# SERVICE LETTER

No. 861

Piper Aircraft Corporation

Subject: Forward Facing Seat Back Modification

# INSTALLATION OF FRICTION WASHERS

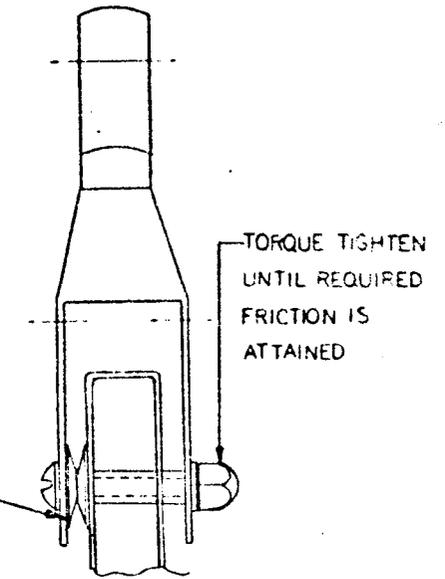
This Service Release announces the availability of an improved method of retaining the rear facing (club) seat backs in an up-right position. Friction washers are installed at the seat back hinge in lieu of the existing clips on the above affected aircraft.

See attached sketch for instructions.

Four(4) each Piper Part Number 408 834V Washers, friction per seat (eight (8) per aircraft) at a suggested list price of \$ .33C each.

408-834  
(2 REQ)
